UNITED STATES PATENT AND TRADEMARK OFFICE

APPLICATION NO.	FILING DATE	FIRST NAMED INVENTOR	ATTORNEY DOCKET NO.	CONFIRMATION NO.
10/812,449	03/29/2004	Pauline Maria Foster-Hamilton	0707-00342 - G00342/US	3169
35758	7590	11/07/2005	EXAMINER	
GKN DRIVELINE NORTH AMERICA, INC 3300 UNIVERSITY DRIVE AUBURN HILLS, MI 48326			DUNWOODY, AARON M	
			ART UNIT	PAPER NUMBER
			3679

Office Action Summary

DETAILED ACTION

FIG. 1

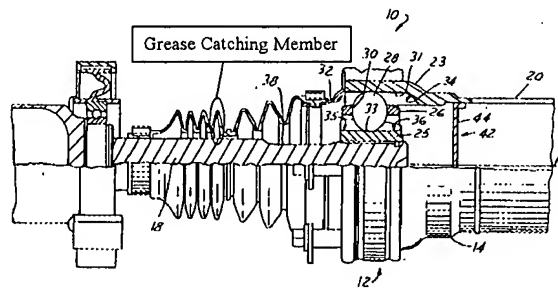
Applicant's arguments filed 9/6/2005 have been fully considered but they are not persuasive. The Applicant argues that neither the boot nor the Examiner provides reference numbers for the boot illustrated in Booker. The Examiner is not required to provide reference numbers for an invention that is clearly anticipated, such the invention anticipated by Booker.

The Applicant argues that Booker does not disclose the features of claim 1, in particular, a grease catching member. The Examiner disagrees. Booker's Figure 1 below clearly illustrates a grease catching member.

Therefore, Booker anticipates the claimed invention.
